Palo Verde Nuclear
Generating Station

**Subject: Palo Verde Nuclear Generating Station (PVNGS)
Units 1, 2 and 3
Docket No. STN 50-528, 50-529 and 50-530
Relief Request No. 24 - Request for Additional Information**

**Response to the Request for Additional Information for Relief
Request No. 24**

Figure 5-2 Three Dimensional Model of the Head Vent Penetration

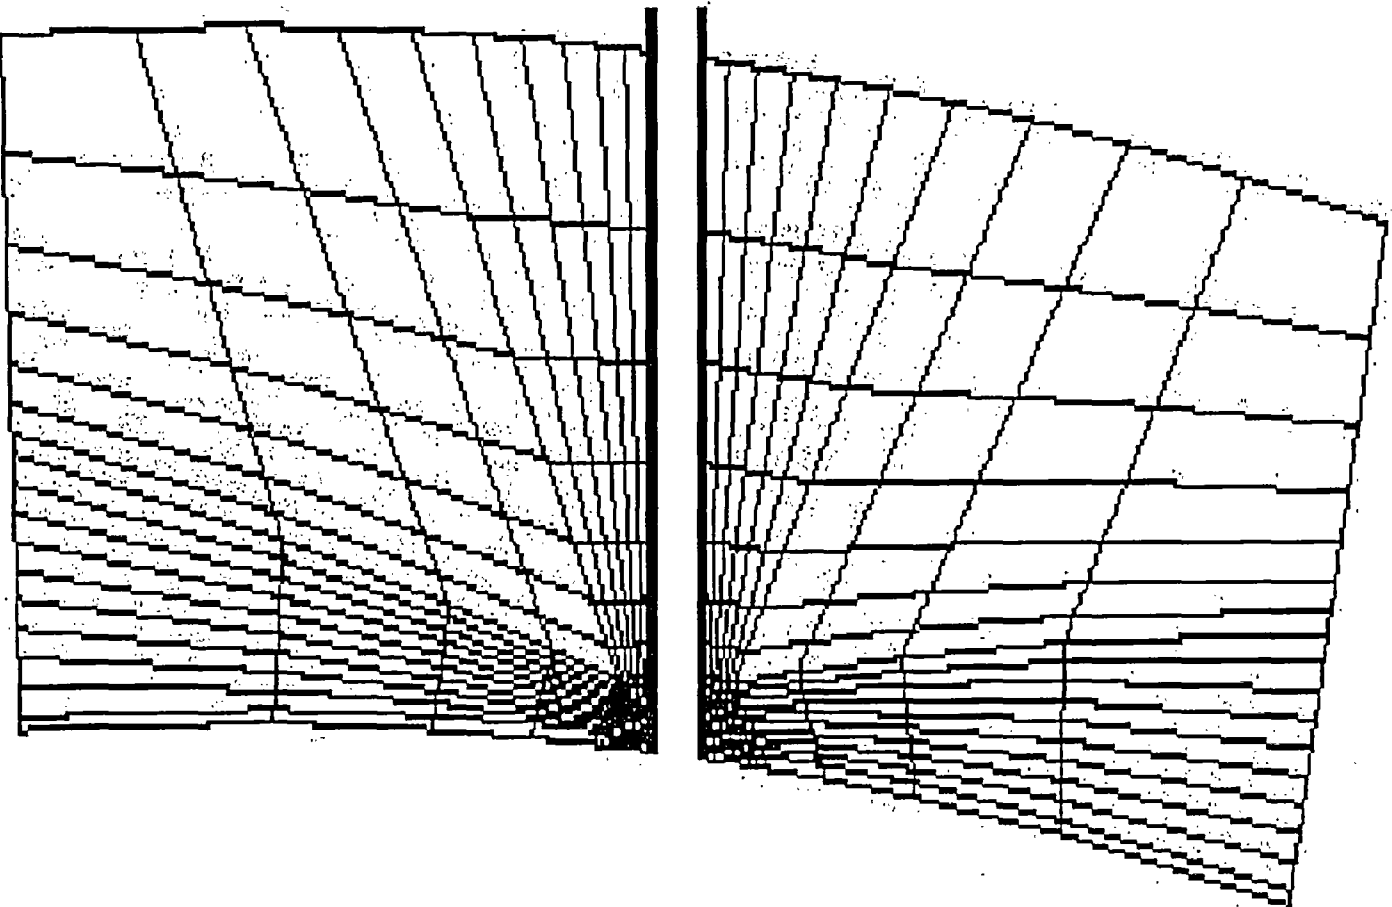
Provide the finite element stress analysis as well as boundary conditions used to calculate tensile stresses on the vent penetration nozzle. How was the plug installation modeled? (i.e. cold work, weld residual stresses)

The critical stress location in the head vent is in the vicinity of the attachment weld, where residual and pressure stresses have the most impact.

The stress analysis for the vent line penetration is based on a three dimensional finite element model. The analysis considered pressure and thermal transient loads

associated with steady state operation, as well as residual stresses which are produced by the fabrication stresses. This modeling process was used for the CEDM nozzles as well. Figures 5-2 and 5-9 from Westinghouse WCAP 15817-P, Revision 1, are provided below to show the model.

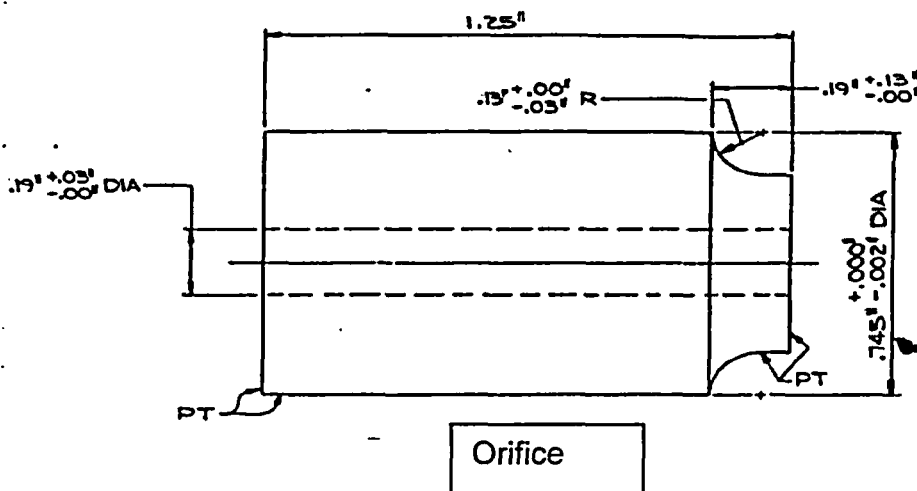
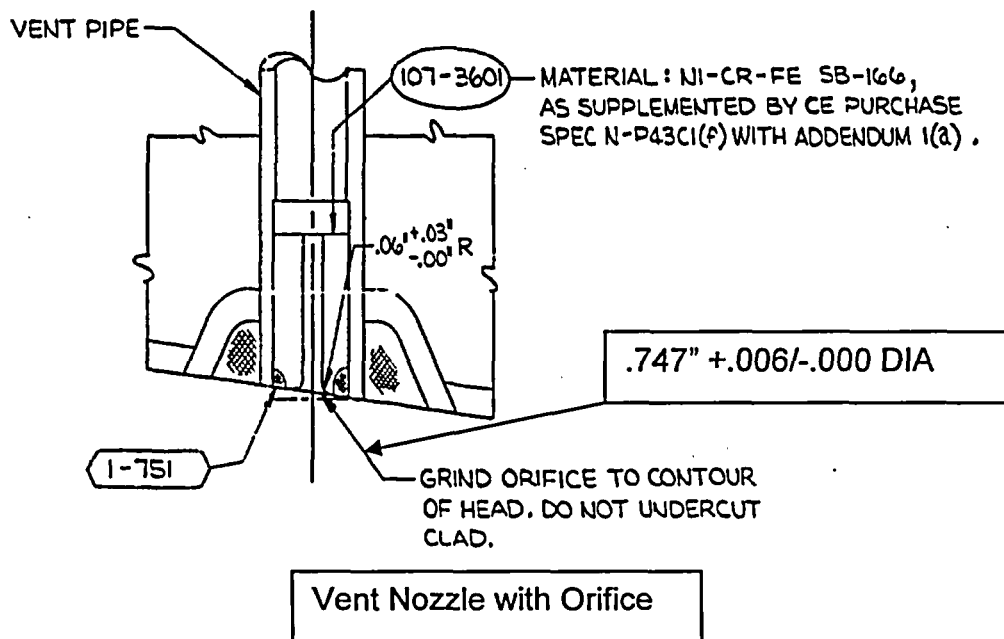
Provide figure of vent penetration nozzle, plug and associated welds with all dimensions.

See the drawings below for design details of the vent line nozzle, plug and weld dimensions.

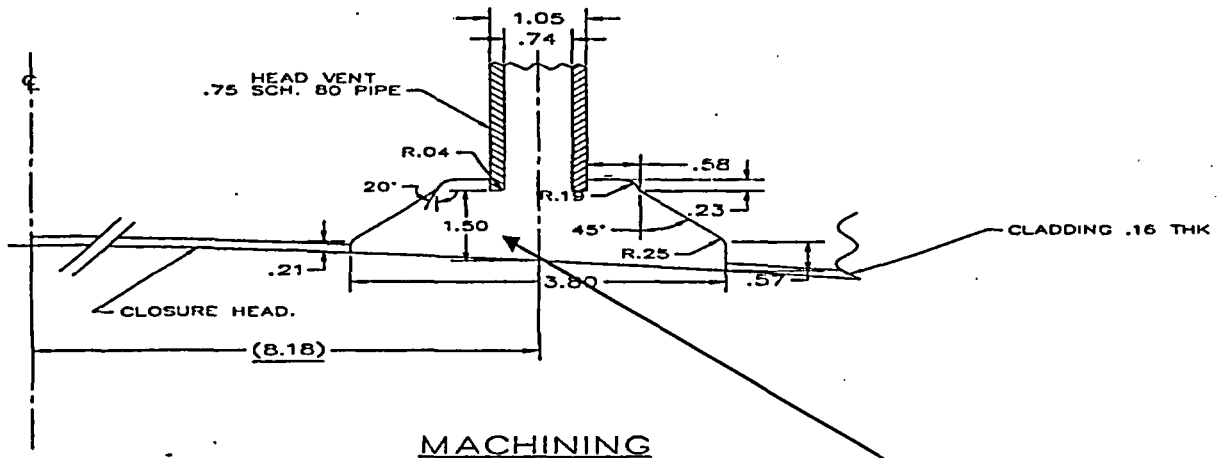
Provide additional details on plug removal method including amount of material removed by EDM process.

For access to the inside diameter of the vent nozzle, the APS vendor proposes an electrode discharge machining (EDM) process to remove the orifice (see the sketch below). This EDM process would remove the orifice, orifice to nozzle attachment weld, vent nozzle and vent nozzle to reactor head attachment weld. More importantly, a substantial portion of the reactor head material would also have to be removed (a 3.80 inch diameter opening is machined, with 1.50 inches of reactor head material removed). The large amount of material removed facilitates a remote welding head which would be used to re-weld the vent nozzle to the reactor head and the orifice. The reactor head material removed is not replaced by weld material. As a result of current regulatory inspection requirements, this EDM process would be repeated in subsequent outages, ultimately resulting in an unacceptable and impractical configuration.

Note: a 3.80" x 1.50" area of RPV head material is removed by this process

Figure 6-21 Crack Growth Predictions for Axial Inside Surface Flaws – Head Vent

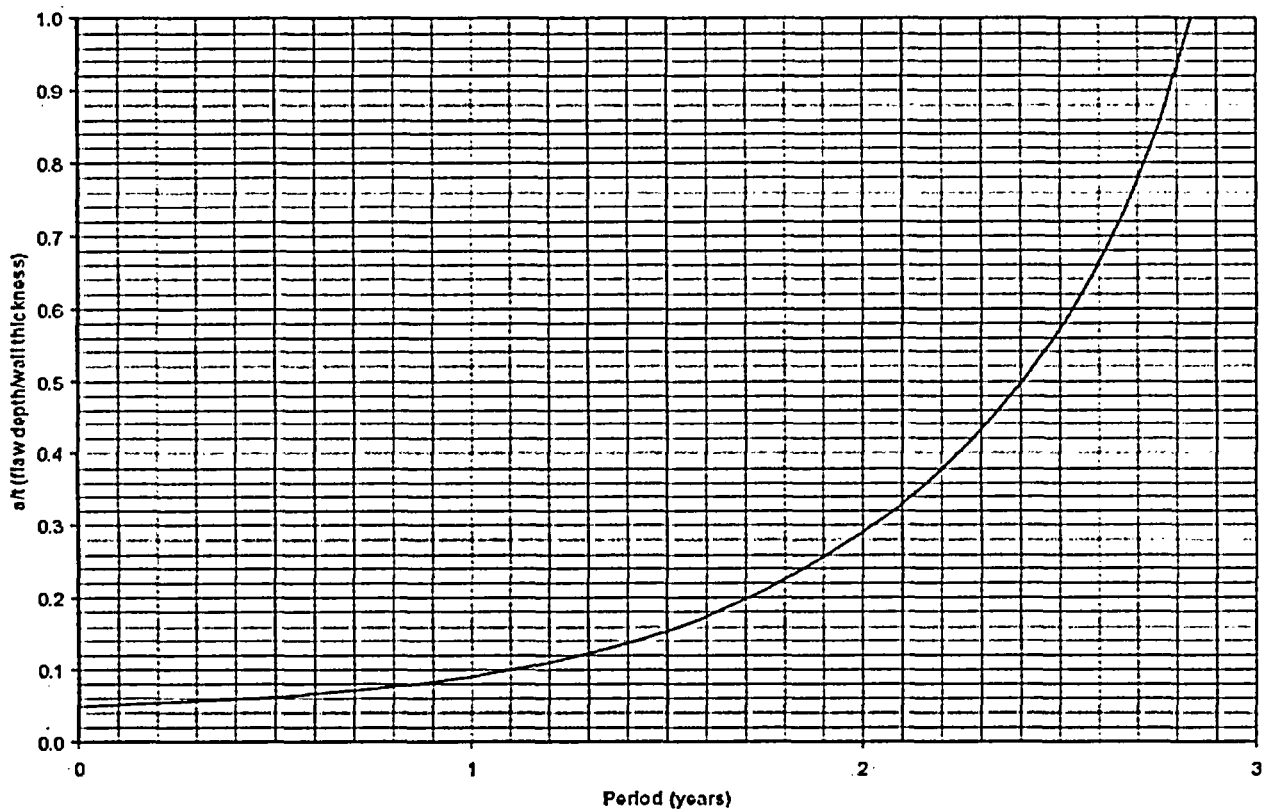
Provide support documentation for the statement, "Should PWSCC occur in the high stress region, crack growth predictions for the head vent pipe show a period of greater than 2 years, from the time of initiation, before through-wall cracking occurs."

The crack growth rate prediction curve for axial inside surface flaws for the head vent nozzle is provide below (WCAP-15817, Revision1)and shows that in the high stress region, crack growth predictions for the head vent pipe show a period of greater than 2 years, from the time of initiation, before through-wall cracking occurs.
